LETTER OF OBJECTION – 13.07.22

Section 4.55 (2) Environmental Impact - Modification of Development Consent DA2021/1790 granted for Alterations and additions to a dwelling house, including a swimming pool and garage

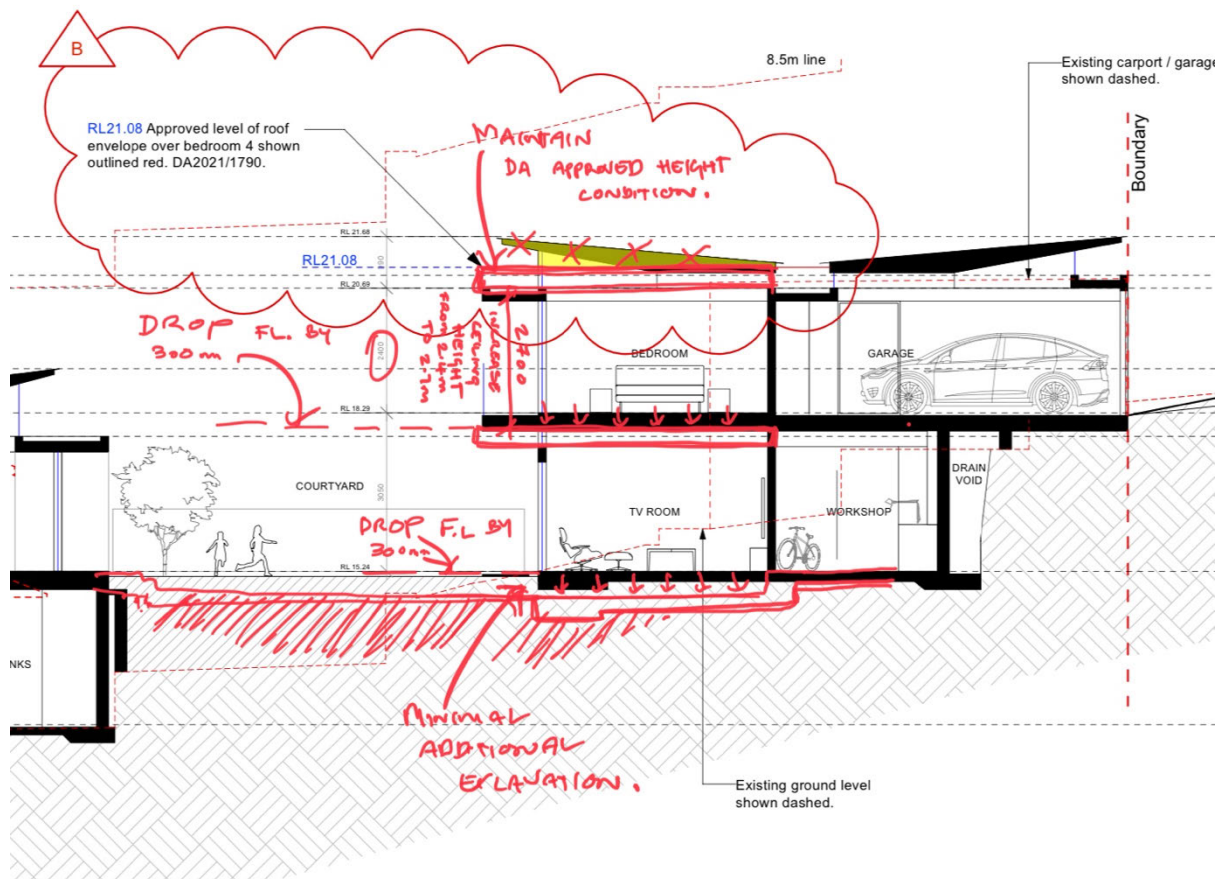
The argument that a 2.4m ceiling will not provide a suitable amenity for a bedroom is not a reasonable argument for our loss of view, especially when the building could quite easily be excavated lower at the ground level or have a stepped down slab by 300mm, in order to achieve their desired 2.7m ceiling height, whilst maintaining the previously approved height line condition at 21.08. Essentially the same cross sectional height for the bedroom within this mod / proposal could be achieved this alternate way. (Refer to sketch below)

This feels like symbolically “giving us the rude finger” as neighbours. We are very disappointed in the moral approach that is being taken here, when a more simple solution can easily be achieved (like in the above sketch), without impacting any more then the existing dwelling and/or previously approved DA and whilst not diminishing the success of the interior experience of the owners bedroom space.
